Addendum No. 1
Four Rivers Sanitation Authority
Maintenance Building Renovation
Capital Project No. 2102

This Addendum Number 1, dated July 17, 2026, for the above-referenced project, supersedes all contrary and conflicting information in the specifications and contract documents, which are hereby supplemented or revised as follows:

7 Storefront Sill Detail
Scale: 3" = 1'-0"

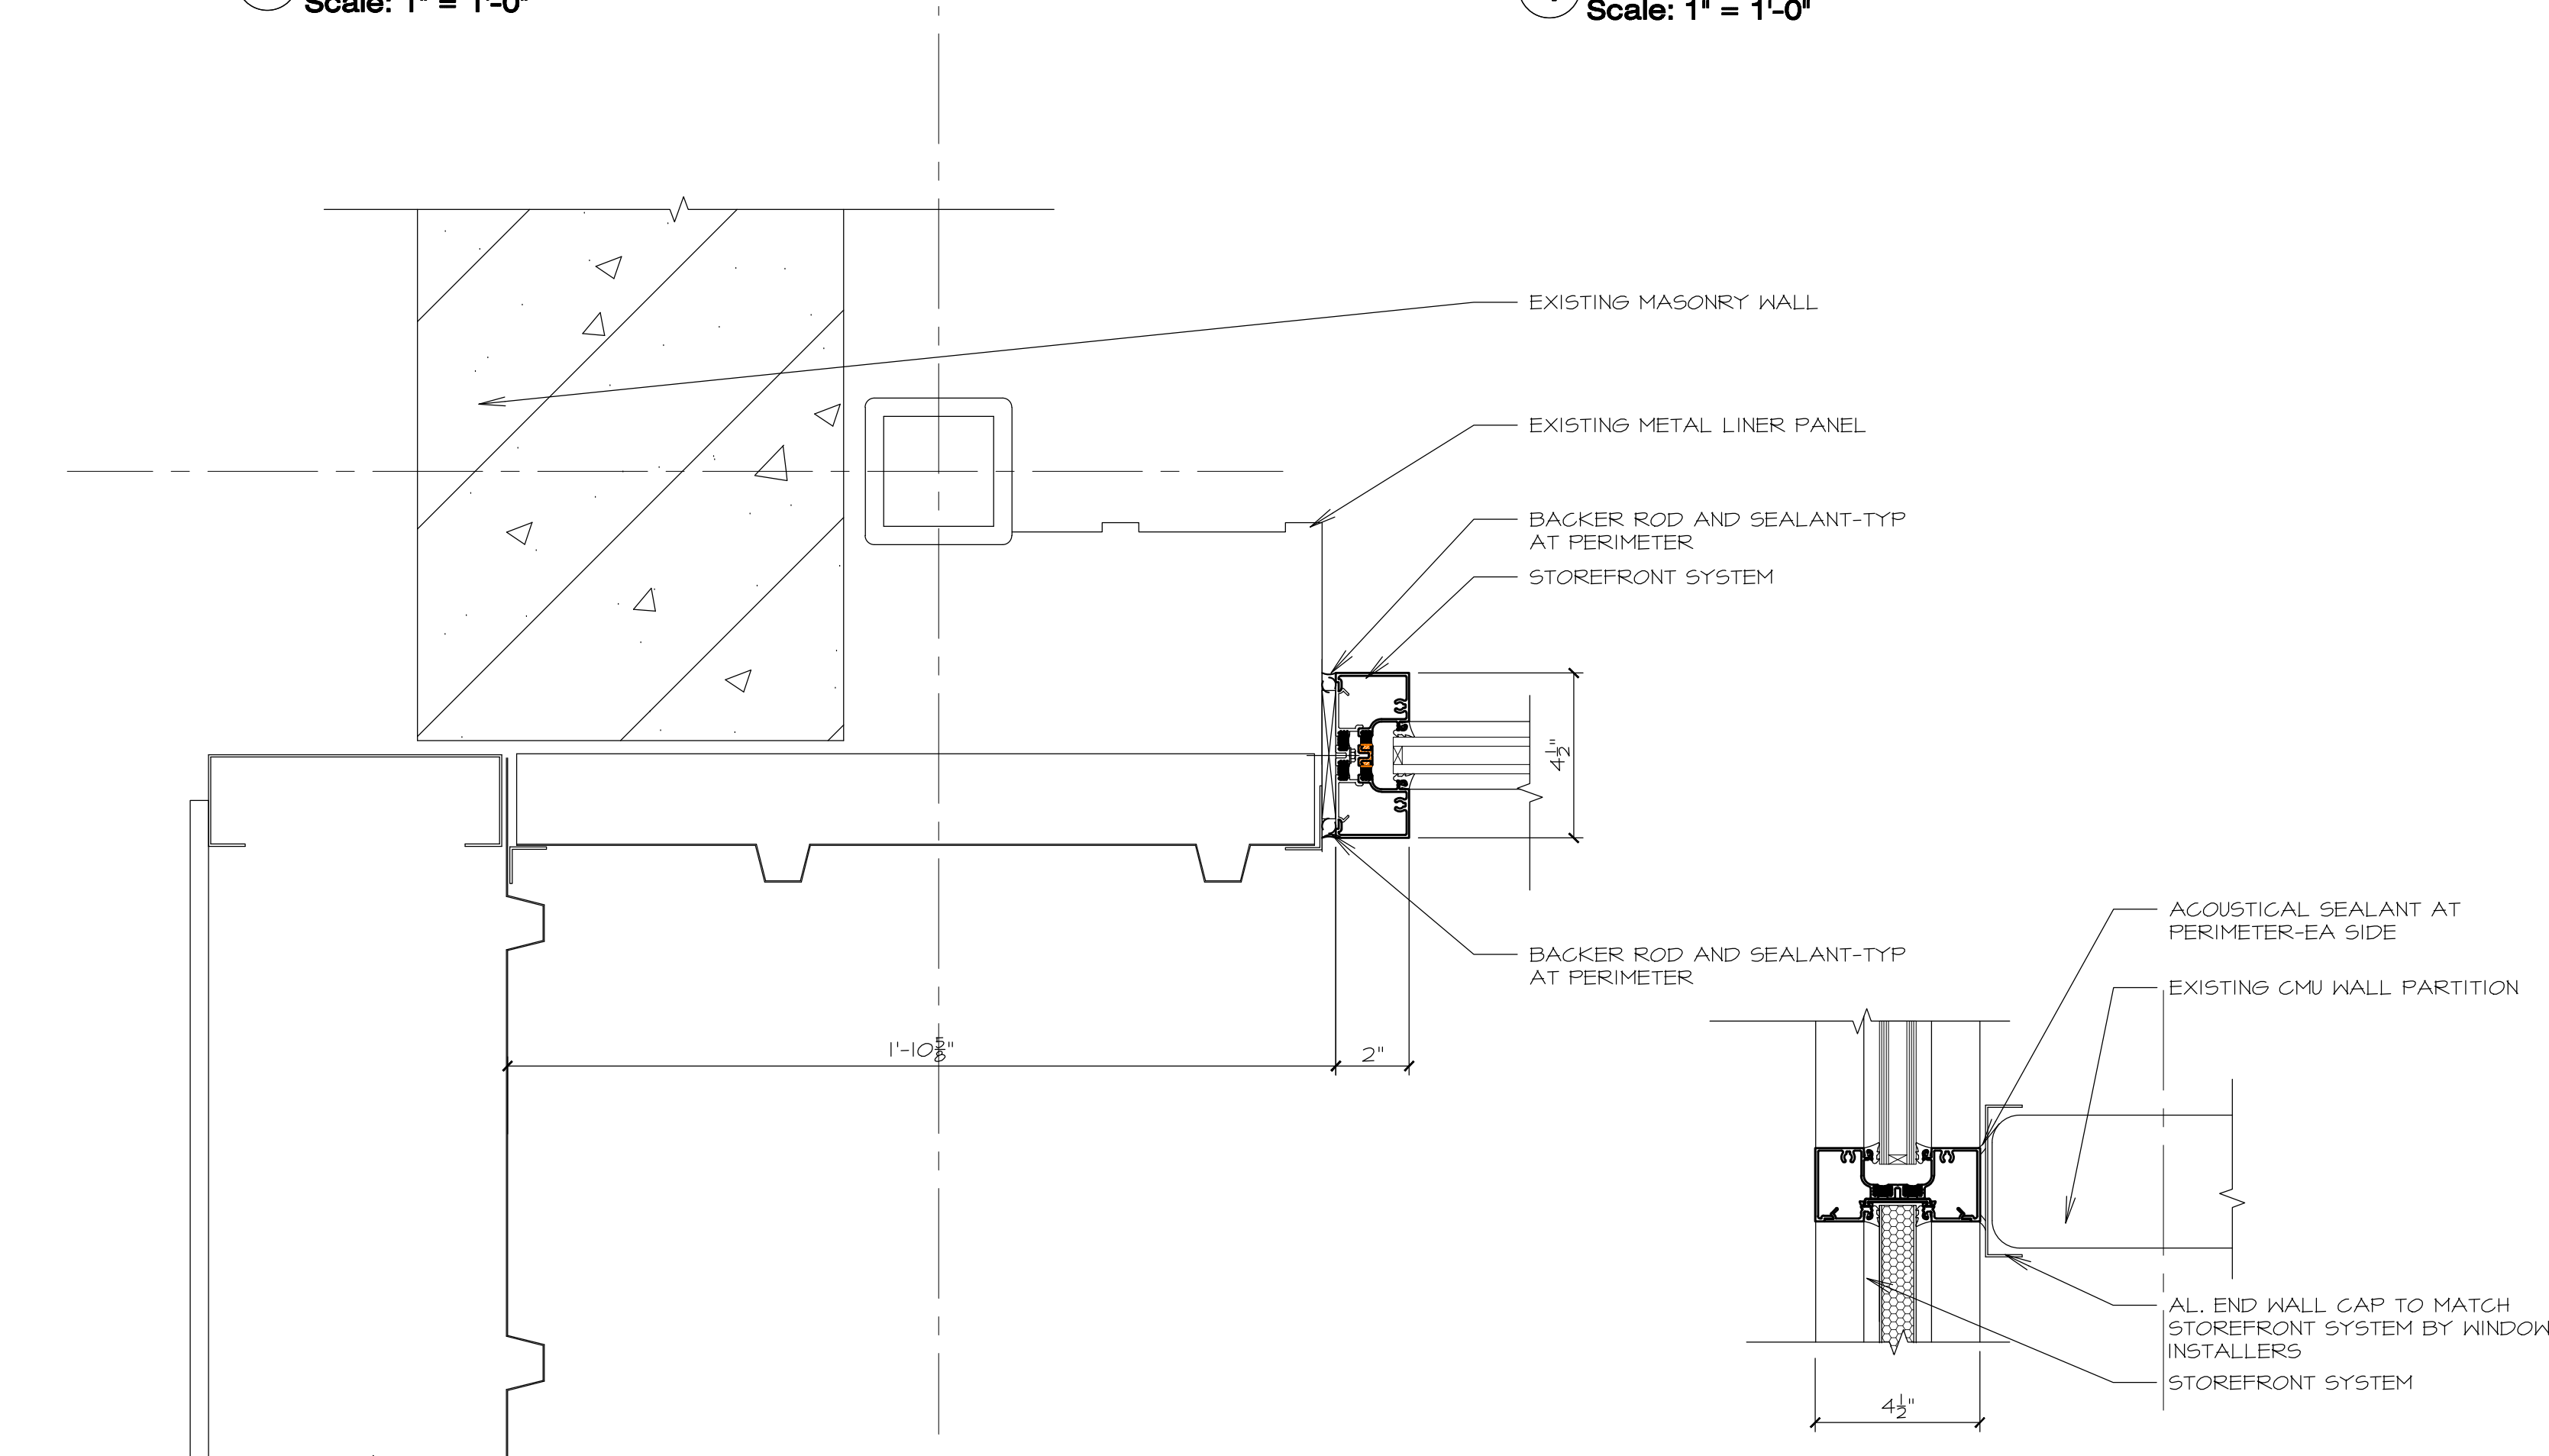
Plan Sheet A501 Details: DELETE Sheet A501 in its entirety and REPLACE with the attached revised sheet which clarifies Alternates and EIFS Options One and Two and corrects steel stud sizes.

Alternate A-1:
Work includes: All work associated with furnishing and installing Exterior Insulation and Finish System (EIFS) belt-course, including removal of existing metal siding and base flashing. See Sheet D201 and this sheet.

Alternate A-1a: Furnish and install EIFS Option One as described in the drawings. See Sheets A501 and A502.

Alternate A-1b: Furnish and install EIFS Option Two as described in the drawings. See Sheets A501 and A502.

3 E.I.F.S. Option Jamb Details
Scale: 3" = 1'-0"

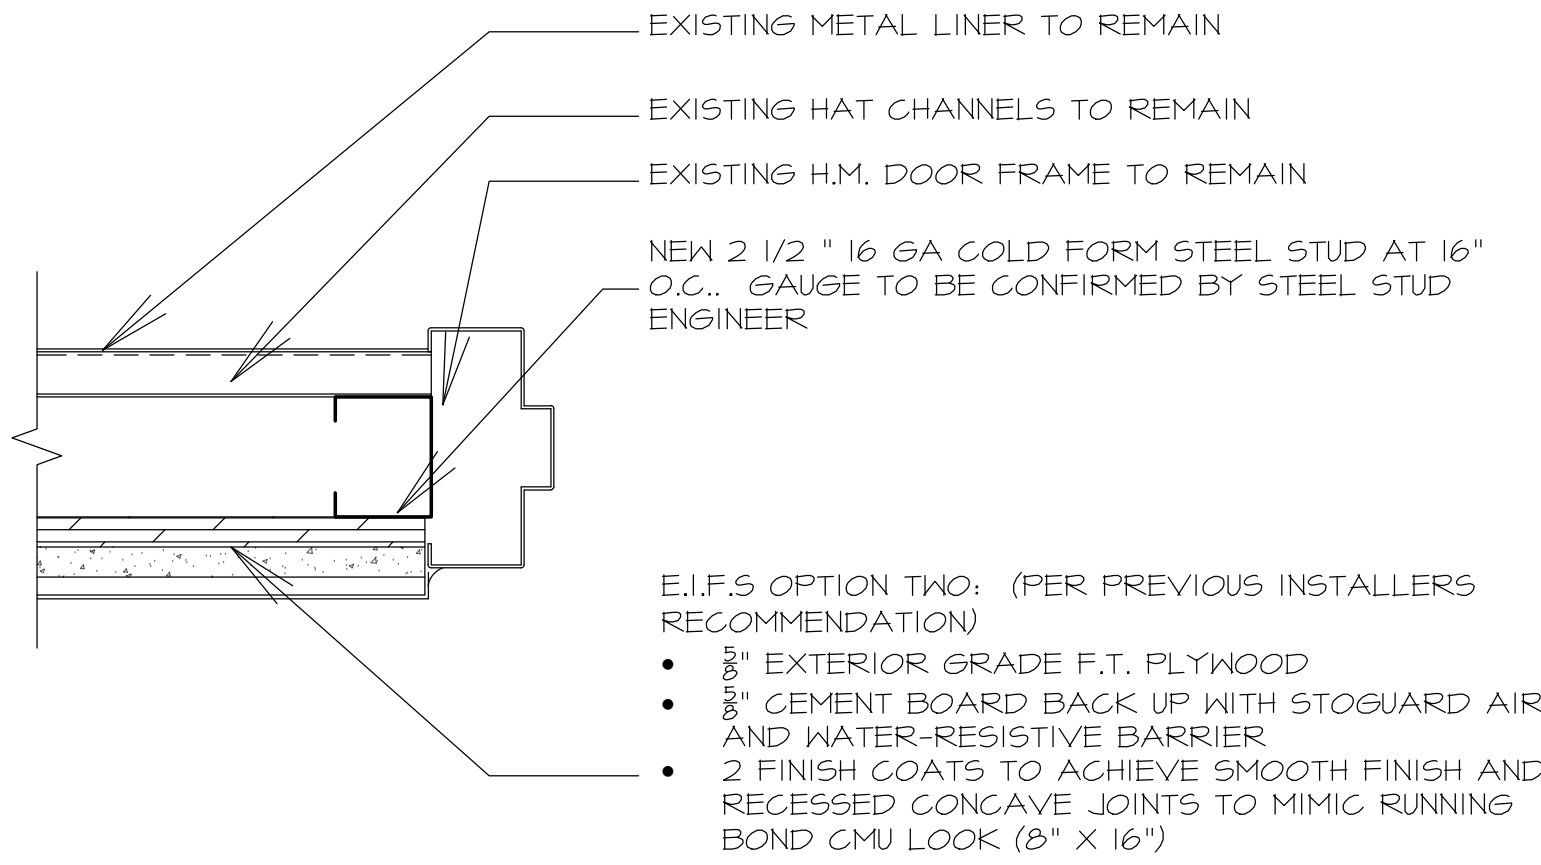
Plan Sheet A502 Details: DELETE Sheet A502 in its entirety and REPLACE with the attached revised sheet which adds an EIFS jamb detail.

ROOF DETAILS -NEW WORK

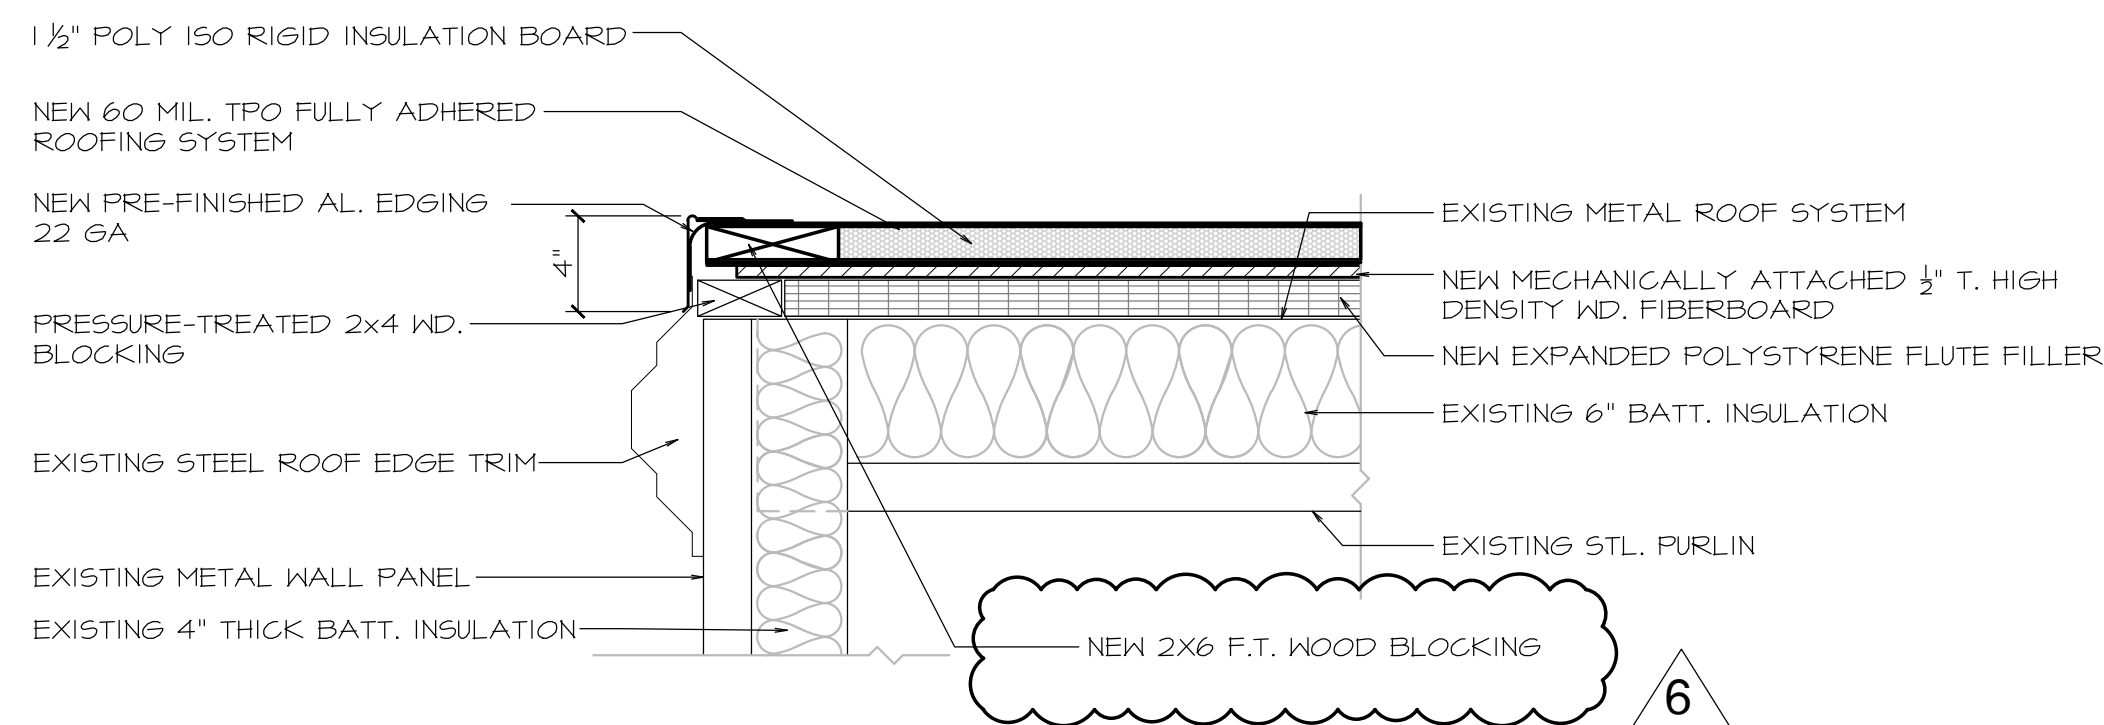
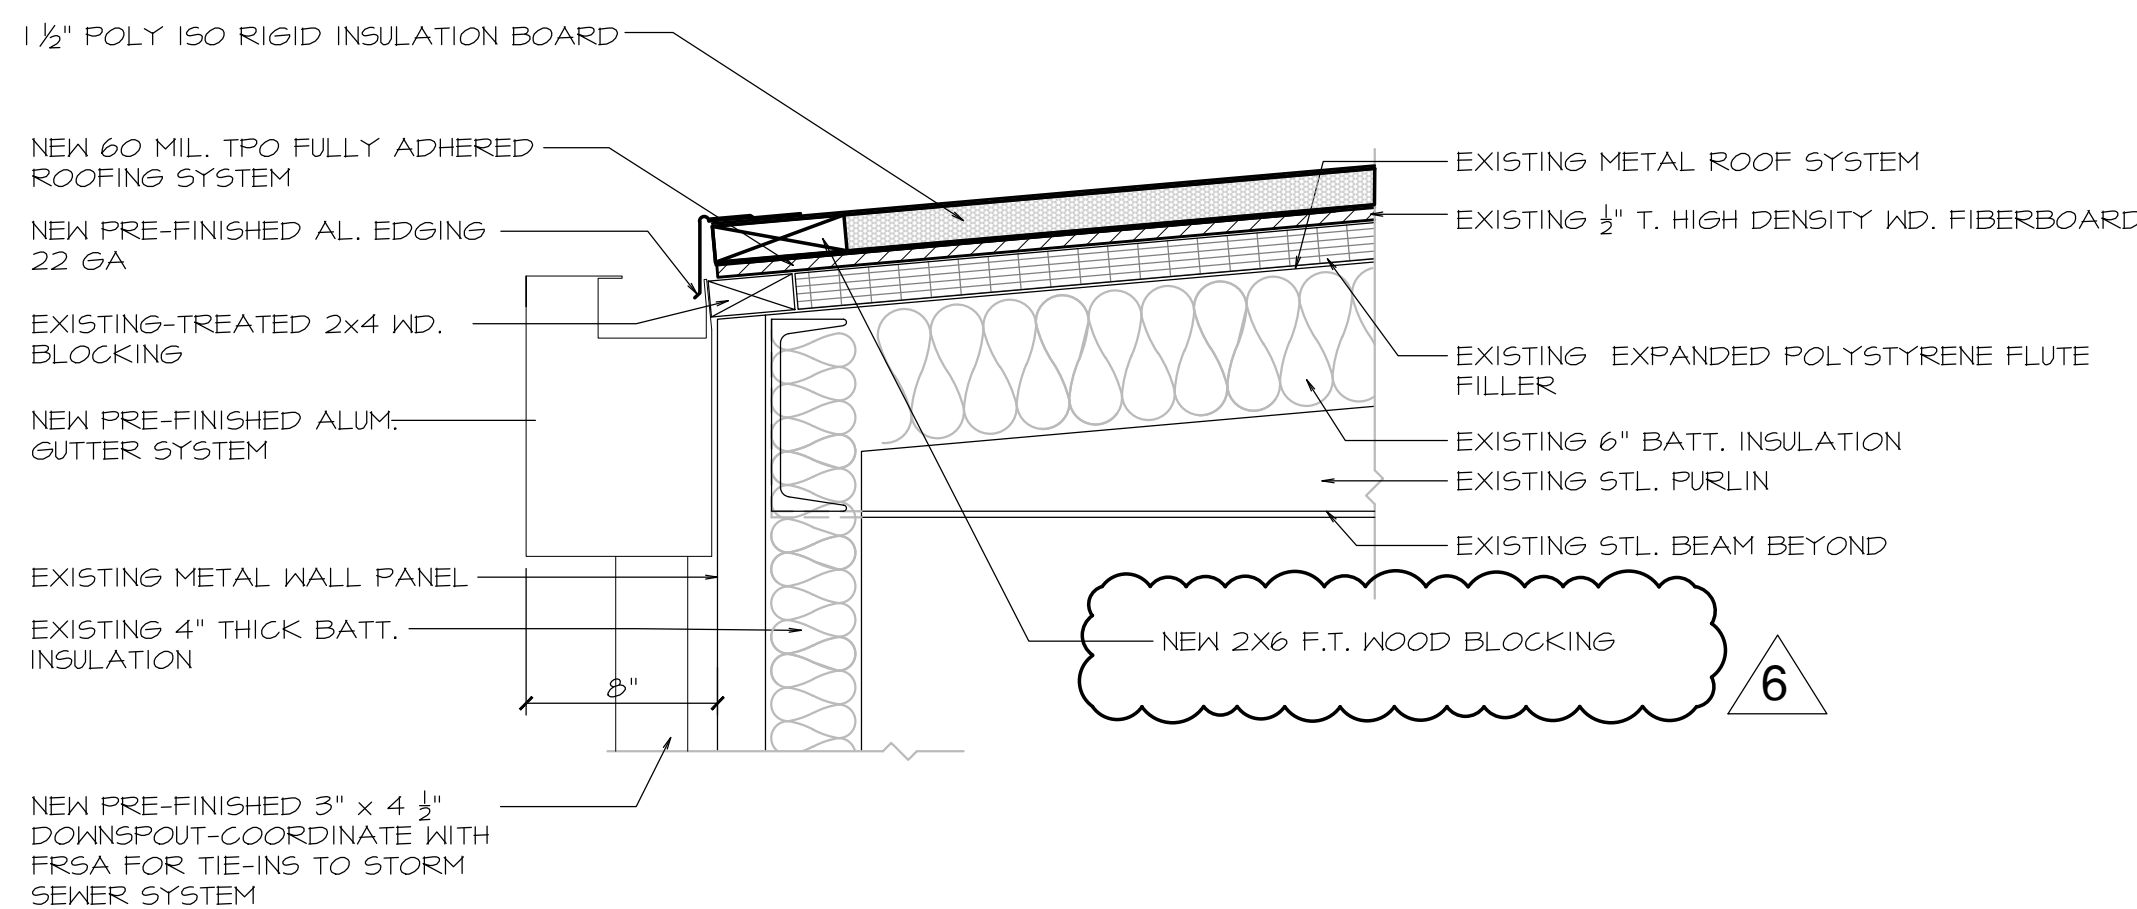
Plan Sheet A601 Roof Details – New Work: DELETE Sheet A601 in its entirety and REPLACE with the attached sheet which clarifies requirements for wood blocking on the eave and gutter details.
